**Premier Gateway Scoped Subwatershed Study
 Phase 1: Study Area Characterization February, 2016
 Response Matrix**

Comments	Response
Conservation Halton – Matt Howatt – May 9, 2016	
Overview	
Conservation Halton staff offer the following comments from a regulatory perspective under Ontario Regulation 162/06 and technical advisory perspective under the Memorandum of Understanding with Region of Halton and local municipalities. The following points are provided as an overview with further detail provided under the appropriate section below.	
Overall, staff appreciate the detailed information provided within the report, specifically regarding Aquatic and Terrestrial Survey Methods, Hydrogeology and Fluvial Geomorphology.	
There is a concern with the flow gauge data being used for validation and calibration of the hydrologic model which must be revisited and agreed upon before established flows can be used in the hydraulic model for hazard delineation.	We note that the flow gauge was sited in consultation with Conservation Halton staff, and the observed trends in terms of runoff response have been verified based upon the characterization of the study area, hence it remains our opinio

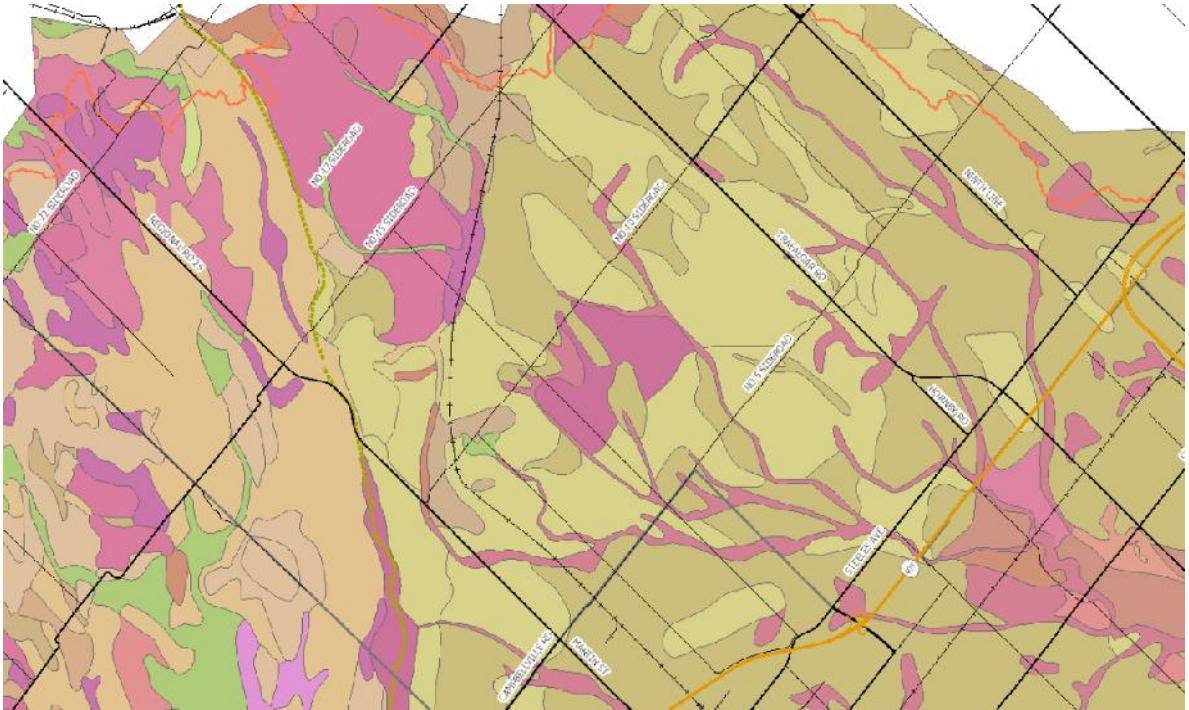
<p>8. Table 2.1.9 Fish Community Assessment Results, Page 35: A photo of the Yellow Bullhead (<i>Ameiurus natalis</i>) is requested to verify the species as it is not typically found within Conservation Halton's watershed.</p>	<p>A photo was not taken of the Yellow Bullhead. Two aquatic biologists conducted the fish community sampling where this species was identified on September 14, 2015. Both biologists have years of experience conducting a variety of aquatic surveys and identifying fish. Both aquatic biologists have</p>

Comments	Response
	excellent fish identification skills and feel confident in their identification of this species.
<p>9. Section 2.1.5.10 Benthic Invertebrate, Page 36:</p> <p>The lack of Gastropoda and Oligochaetes may not indicate impaired conditions. Site conditions should not be classified based on one or two metrics/indices but on the cumulative results.</p>	<p>It is noted that single metrics do not necessarily characterize the state of a given stream, however the overall condition of each site was based on the analysis of multiple indices. It can also be noted that the lack of any one group may have little effect on the condition of the site. See the response for Comment 5.c) for further discussion.</p>
<p>10. Section 2.1.6.1 Significant Wetlands, Page 38:</p> <p>Recent direction from Aurora District MNRF is that all unevaluated wetlands are assumed to be provincially significant (PSW) until evaluated and demonstrated to be otherwise, in order to demonstrate conformity with the PPS Policy 2.1.4a). Staff are not in agreement with the approach that the wetlands are “too small to be evaluated on their own merit, as they are less than 2ha in area” for the following reasons:</p>	<p>It should be clarified that the MNRF wants unevaluated wetlands to be treated as provincially significant where they are proposed for development prior to an evaluation and does not want the assumption made that they are provincially significant (personal communication with J. Burkart, July 13, 2016).</p> <p>MNRF agrees that the wetlands within the Premier Gateway lands do not need to be evaluated through OWES (personal communication with Steve Varga, September 8, 2016).</p> <p>October 24, 2016 Meeting: Compensation to be discussed in Phase 2. Buffers to be established (CH requirements and Region requirements if not designated PSW's). Additional text to be included in final report to document discussions with MNRF and MNRF concurrence. Wetland compensation may be permissible for “non-significant” wetlands subject to further discussion.</p>
